160612 Eric Strid comments on the MBTL DEIS

India and China's Coal Import Demand, 1990 to 2021

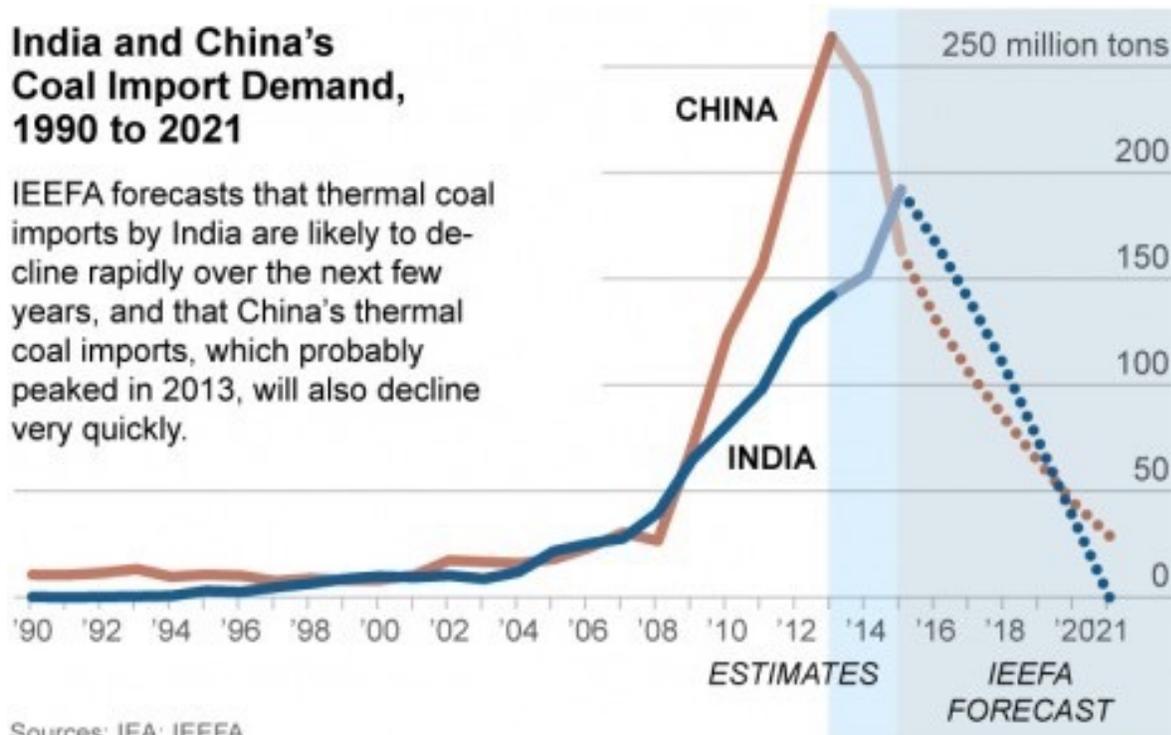
The DEIS is deficient in its use of outdated market data in the SEPA Coal Market Assessment Technical Report. For example, Figure 12 shows China coal imports rapidly rising through 2012, while in fact those imports peaked in 2013 and have declined since then. India was supposed to ramp up its coal imports, but the latest forecasts (and news reports) show both China and India coal exports dropping dramatically¹:

IEEFA forecasts that thermal coal imports by India are likely to decline rapidly over the next few years, and that China's thermal coal imports, which probably peaked in 2013, will also decline very quickly.

Due to wrong data inputs, most of sections 4, 5, 6, and 7 in the SEPA Coal Market Assessment Technical Report are grossly in error. The entire report must be redone for the EIS, using updated actual demand and prices, and more realistic assumptions about future demand, especially in light of continued low natural gas prices worldwide and continuously decreasing costs of wind and solar electricity.
